AMENDMENT I

PROPOSED CHANGES TO SECTION 6.0, ADMINISTRATIVE CONTROLS,
OF APPENDIX A OF FACILITY OPERATING LICENSE DPR-64,
TECHNICAL SPECIFICATIONS

Power Authority of the State of New York
February, 1978

AMENDMENT II

FIGURE 6.2-1
MANAGEMENT ORGANIZATION CHART
INDIAN POINT 3 NUCLEAR POWER PLANT

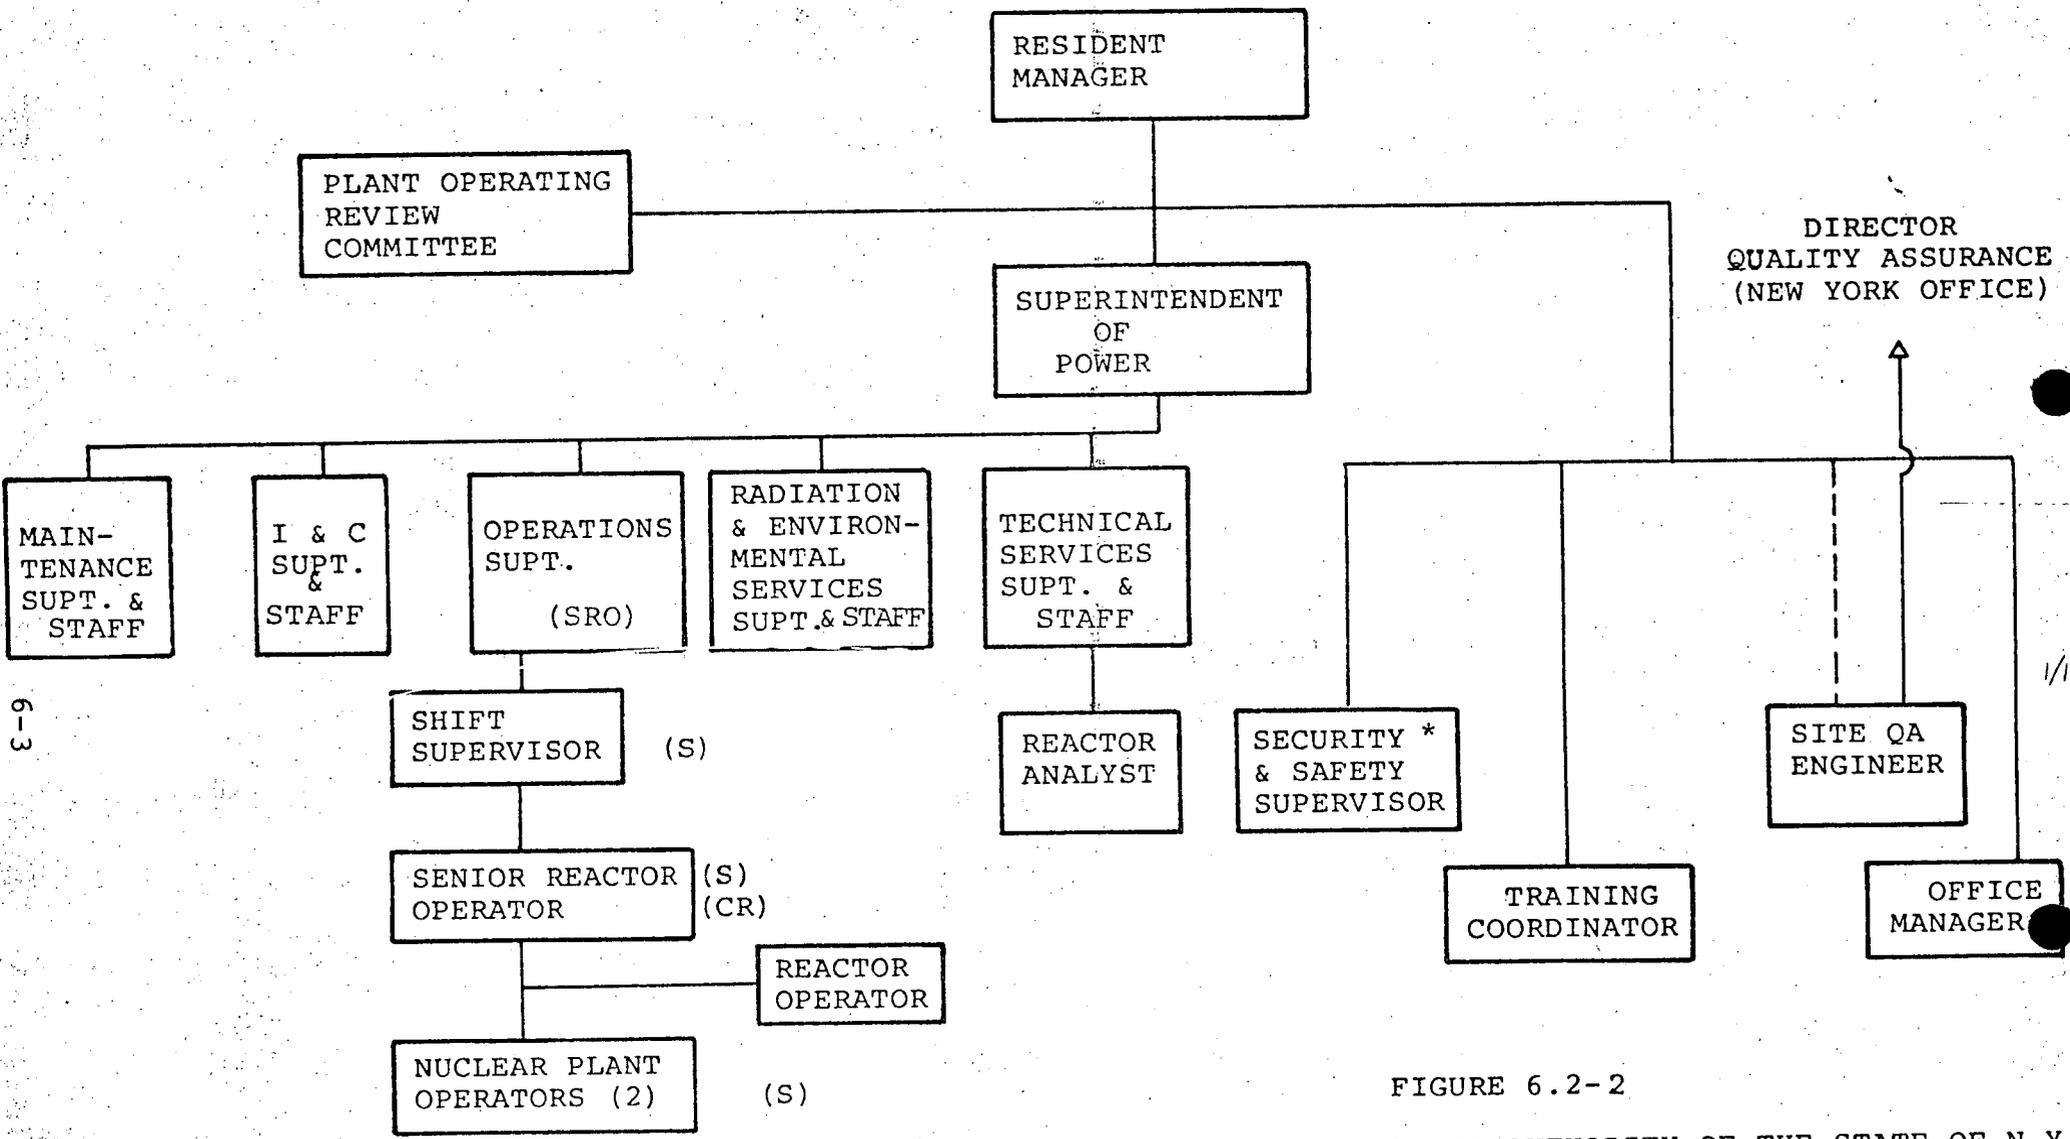
- a. Changes transmitted in the Power Authority's submittal dated December 20, 1977 (IPO-40).
- b. Changes to sections 6.8 and 6.9 as requested by NRC staff.
- c. Changes to Figure 6.2-2 and section 6.12 as requested by NRC during the inspection of January 9-13, 1978.
- d. Changes to section 6.2 for clarification of plant staff requirements for safe shutdown.
- e. Changes to section 6.5 for clarification of membership requirements of the Safety Review Committee in a manner consistent with present Con Ed Technical Specifications.

6.2.1 The offsite organization for plant management and technical support shall be as shown on Figure 6.2-1.
